**[Docket No. FAA-2021-0189; Project Identifier AD-2020-00645-R; Amendment 39-21875; AD 2021-26-16]**

**Airworthiness Directives; Various Restricted Category Helicopters**

**ACTION:** Final rule.

Figure 1 to the Introductory Text of Paragraph (g)(3) – Main Driveshaft Installation and Removal Tool

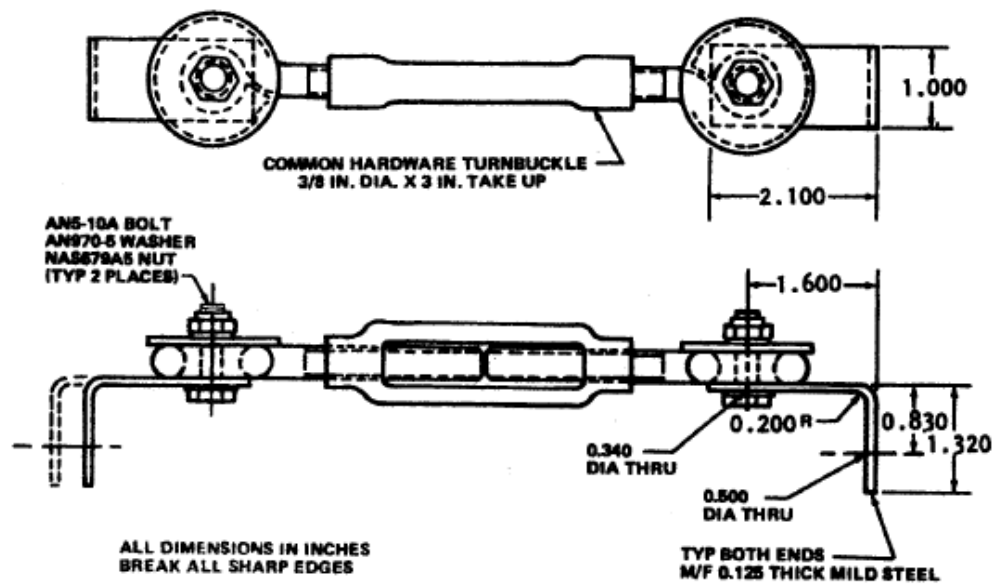
(3) Within 25 hours TIS after the effective date of this AD, remove main driveshaft P/N SKCP2180-1, SKCP2281-1, SKCP2281-1R, or SKCP2281-103 by following "6-24.3. Removal—Main Driveshaft P/N SKCP2281-103" on page 6-24, including "4-24. Removal – Air Inlet Filters" on page 4-17 and "Figure 4-9. Engine Air

Inlet Filter Installation” on page 4-16, of Headquarters, Department of the Army, Aviation Unit and Intermediate Maintenance Instructions Army Model UH-1H/V/EH-1H/X Helicopters, Technical Manual TM 55-1520-210-23-1, Change No. 42, dated April 14, 2003 (TM 55-1520-210-23-1 C 42), except where instructed to “refer to figure 6-12.2” in TM 55-1520-210-23-1 C 42, refer to Figure 1 to the introductory text of paragraph (g)(3) of this AD, and where instructed to “see figure 6-12.3” in TM 55-1520-210-23-1 C 42, see Figure 2 to the introductory text of paragraph (g)(3) of this AD, and:

Figure 2 to the Introductory Text of Paragraph (g)(3) – Work Aid Tool Installed on Main Driveshaft

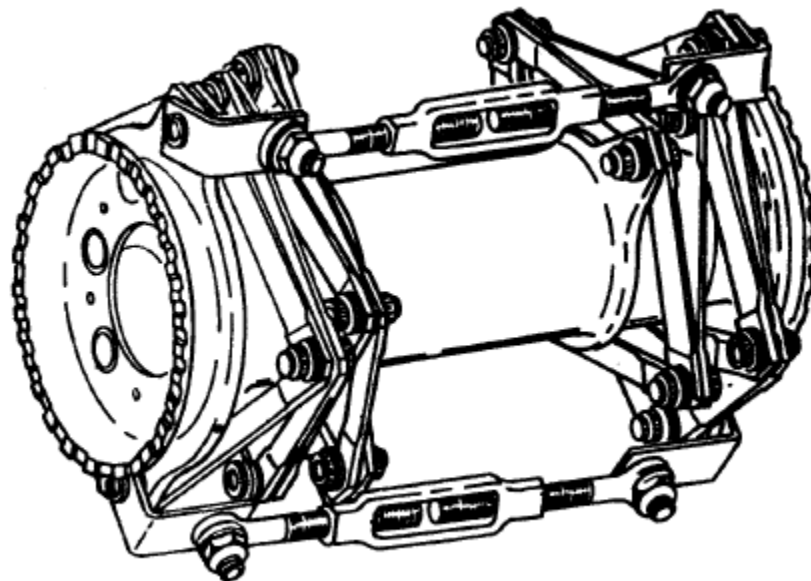
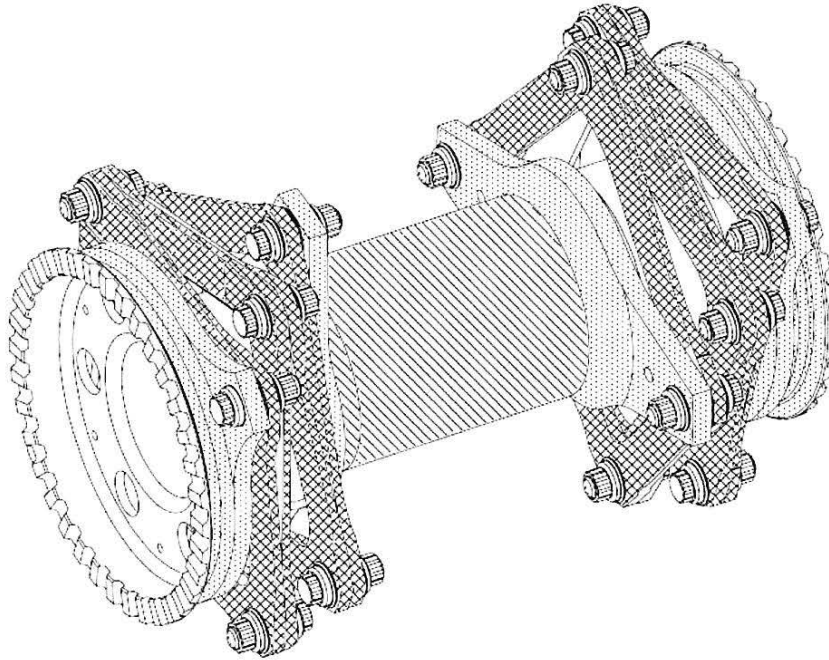
(i) Inspect for any broken, loose, or missing hardware. If there is broken or loose hardware, before further flight, remove the main driveshaft from service. If there is missing hardware, before further flight, replace the main driveshaft. The main drive shaft may be overhauled in accordance with FAA-approved procedures to accomplish the replacement required by this paragraph.

(ii) Visually inspect each flex frame and mount bolt torque stripe (red or yellow) for movement. If there is any torque stripe movement, before further flight, replace the main driveshaft. The main drive shaft may be overhauled in accordance with FAA-approved procedures to accomplish the replacement required by this paragraph.

(iii) Visually inspect each joint for fretting corrosion, which may be indicated by red metallic particles. If there is any grease, oil, or dirt covering a joint, clean the area and visually inspect again. If there is any fretting corrosion, before further flight, replace the main driveshaft. The main drive shaft may be overhauled in accordance with FAA-approved procedures to accomplish the replacement required by this paragraph.
